OC Transpo Transitway Station Design Safety Study

Independent Safety Study

Final Safety Study

September 2021

Issue 17: Curved shape of overhead canopy and station roof dropping snow and water onto transitway lane

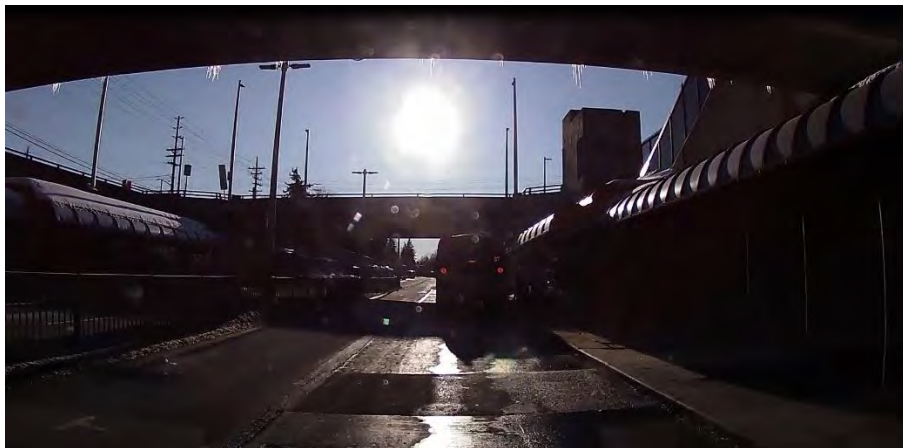
The convex shape of the roof and canopy at the station deposits snow and water onto the sidewalk and transitway surface at the station. This is a potential issue for icing during certain times of the year which could impact surface friction on the transitway and slipping/falling hazard on the sidewalk.

Remove canopy as it cannot be made frangible or shielded. Alternatively install an eavestrough to capture water dripping on the transitway.

Issue 32: Main Active Transportation Crossing – Unclear guidance for users

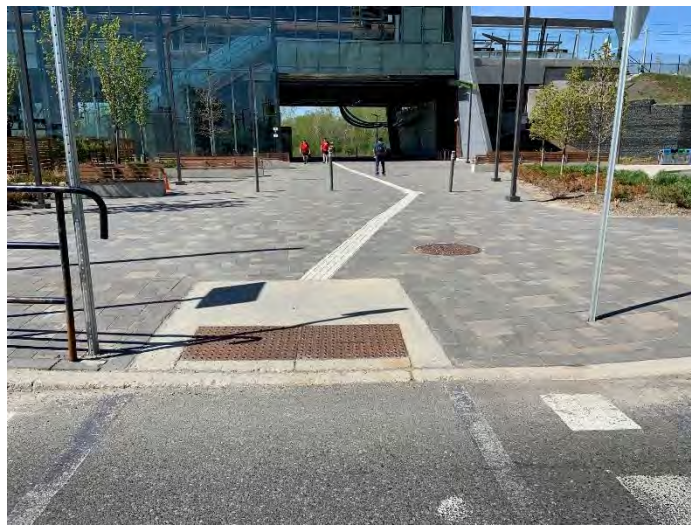
To the southeast, an asphalt MUP transitions to concrete before meeting the crossing. While not regulatory, in Ottawa this is commonly used as a visual queue for cyclists that they should dismount and walk.

It should be confirmed whether a mixed crossride is appropriate and desirable for this location. OTM Book 18 notes that mixed crossrides are “for low volume crossings, particularly at unsignalized locations where practitioners do not anticipate queuing of pedestrians or cyclists”. This does not appear to be a low volume crossing, and queuing of users would be anticipated after trains disembark creating a surge of users.

If a mixed crossride is deemed to not be appropriate, the crossing could be converted to a traditional crosswalk. Alternatively, it could be converted to a separate or combined crossride. These are suitable for higher volume crossings but would require physical modifications to widen the depressed curbs and reconfigure the approaches.

Regardless of the crossing type selected, the pavement markings should be made clear to users. Markings that are still in effect should be refreshed, and markings that are no longer in effect should be removed by abrasive blasting.

The intended use of the approaches should also be made clear to users. If a mixed crossride is deemed to be suitable, “cyclist yield to pedestrians” signs should be installed on the MUP approaches. This would give positive guidance to users that cycling is permitted and reinforce that cyclists must yield to pedestrians in mixing zones.

If it’s decided to convert the crossing to a traditional crosswalk, “dismount and walk” signs should be installed on the MUP approaches. If it’s decided to convert the crossing to a separate or combined crossride, the approaches should be modified to separate users. Markings, signage, and tactile delineation would be required to clearly indicate the separation to users.

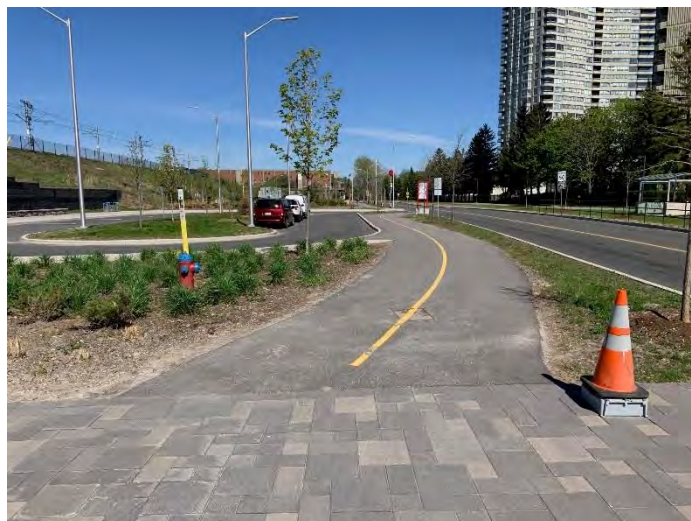
The north side of the crossing meets the station plaza. The paver surface and directional tactile pavers imply to users that it's intended as a pedestrian area, but again no clear guidance is given to users.

To the northeast, a MUP connects to the plaza without any signage or guidance for users.
